Sunnyside Cogeneration Associates

RE: DOGM Permit Amendment Application
Sunnyside Cogeneration Associates
Star Point Waste Fuel C/007/042

Title: Sediment Ponds 5 & 6 map revision

733.120a

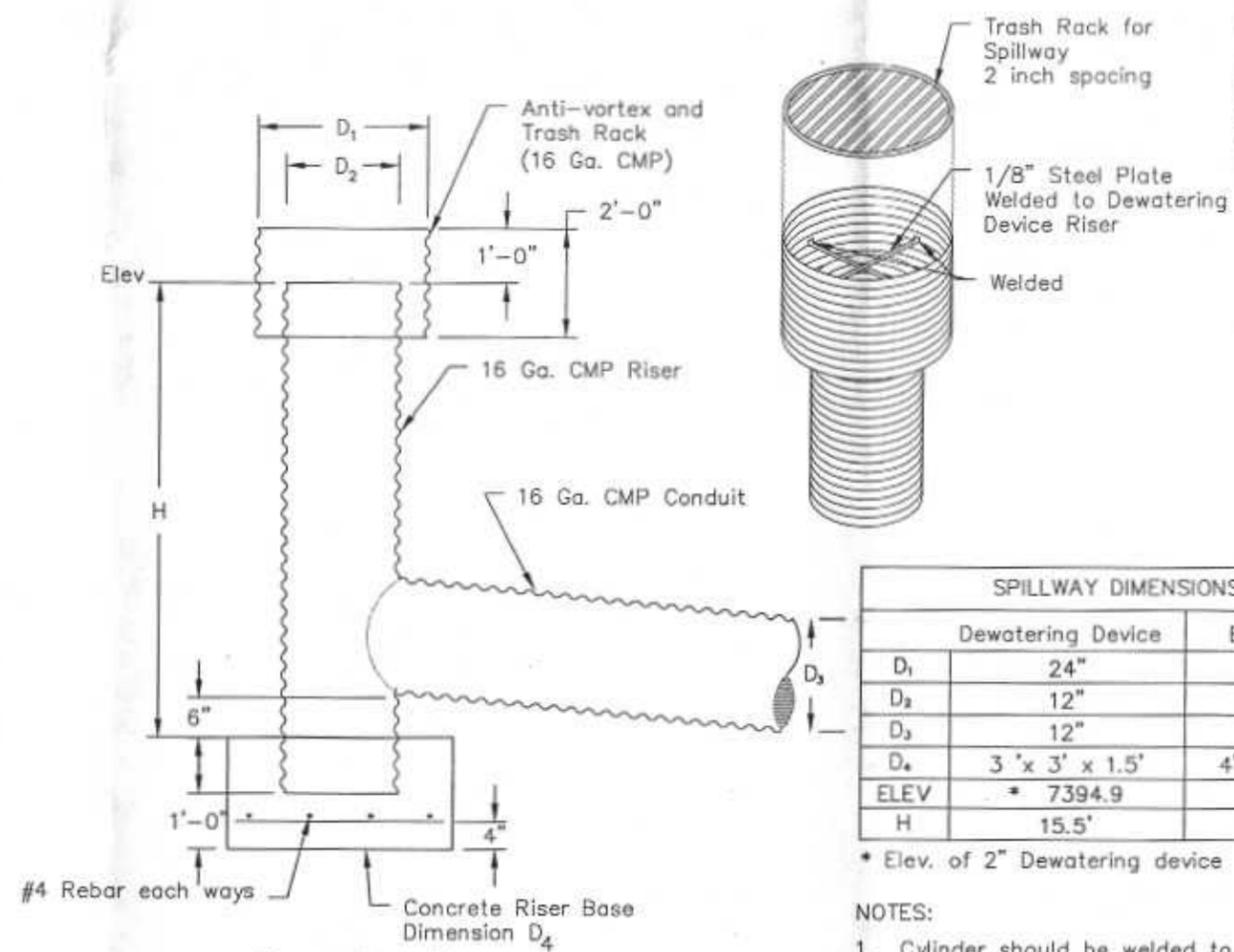
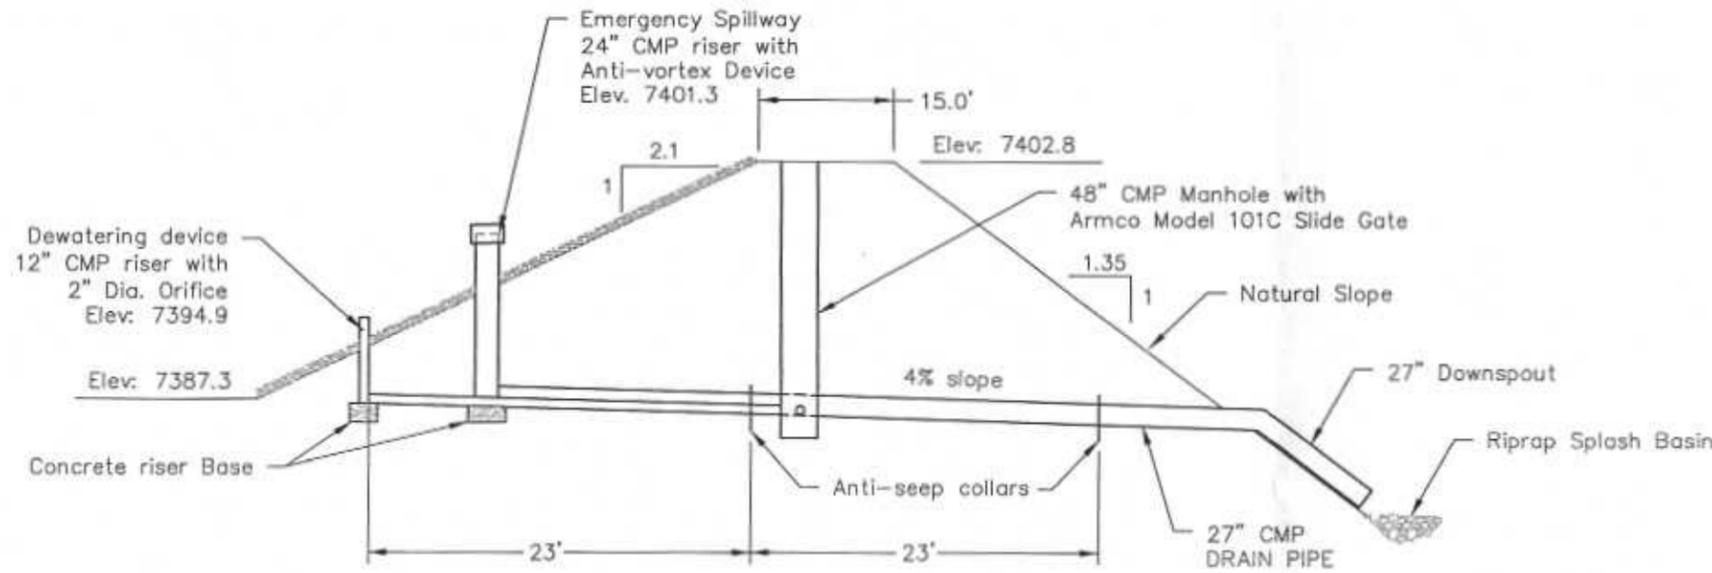
This amendment addresses some differences between permit drawings and what is actually in the field. Permit drawings, for Ponds five (drawing 733.120a) and six (drawing 733.120b) regarding the height of the de-watering riser details, do not match actual field details.

Update drawings for ponds 5 and 6. Adjust dewatering devise to match conditions in field per inspection request from Carl Carpenter.

SPILLWAY DIMENSIONS		
	Dewatering Device	Emergency
D ₁	24"	42"
D ₂	12"	30"
D ₃	12"	27"
D ₄	3' x 3' x 1.5'	4' x 4' x 2'
ELEV	* 7394.9	7401.3
H	15.5'	15.5'

* Elev. of 2" Dewatering device
